UNITED STATES PATENT AND TRADEMARK OFFICE

APPLICATION NO.	FILING DATE	FIRST NAMED INVENTOR	ATTORNEY DOCKET NO.	CONFIRMATION NO.
10/719,694	11/21/2003	Gary J. Crow	018695-9325-00	1344

Office Action Summary

DETAILED ACTION

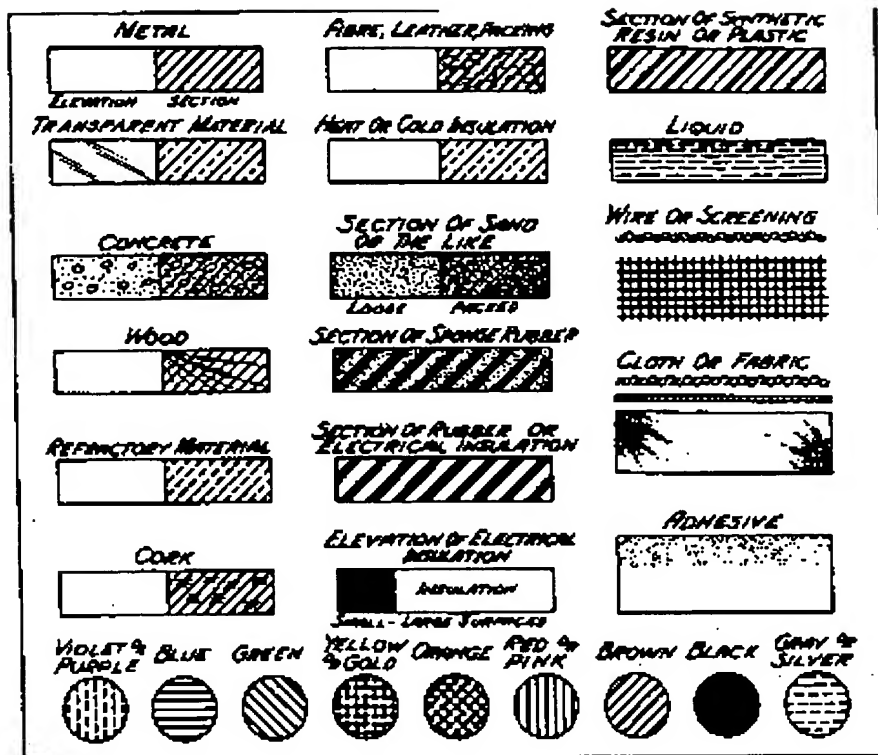
The drawings are also objected to because of the following informalities:

Fig. 15: Gasket 226 is incorrectly hatched for metal. Accordingly, proper cross-sectional hatching is required to properly denote thermally insulative materials for gasket 226 in accordance with MPEP 608.02 (see the drawing below for proper hatching examples). To clearly show this feature and to ensure adequate thickness for the insulative hatching, applicant must add an enlargement of the relevant portion of Fig. 15 focusing on the detail adjacent gasket 226, edges 46, and cover 34. A figure label related to Fig. 15, such as Fig. 15A, is recommended for the new figure. Applicant is reminded to amend the specification accordingly in conjunction with the drawing change; however, applicant is cautioned against the inclusion of new matter.

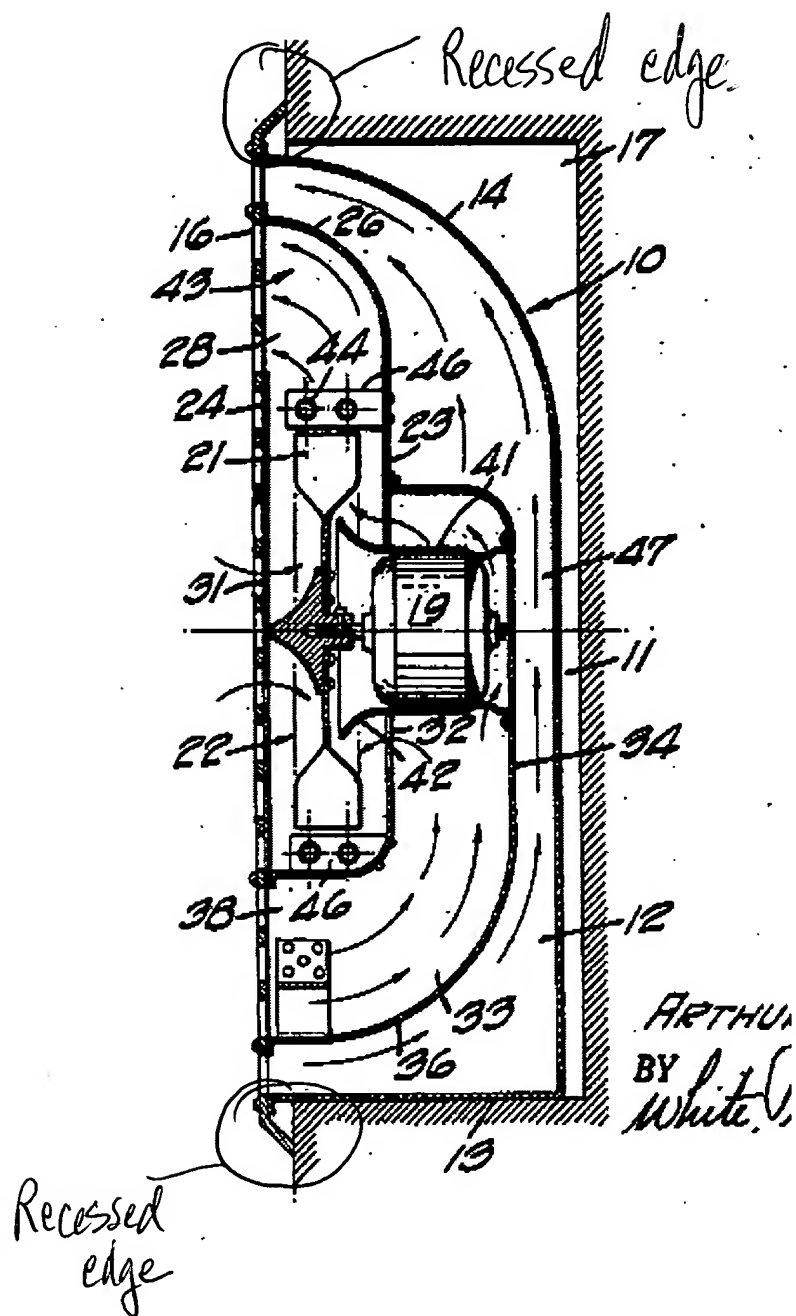
Claims 1-6, 8, 9, 19, and 25-27 are rejected under 35 USC 102(b) as being anticipated by Karg (US 1,644,595). Karg (US 1,644,595) discloses a ventilating and heating apparatus comprising main housing 7, fan housing 52, and fan 47 located within fan housing 52. Air is directed through discharge duct 48 and exits via discharge outlet 56. Electric heater 41 is located within the discharge duct and is "shielded" from discharge outlet by walls 53 and 54 of the discharge duct. See Figs. 5-7.
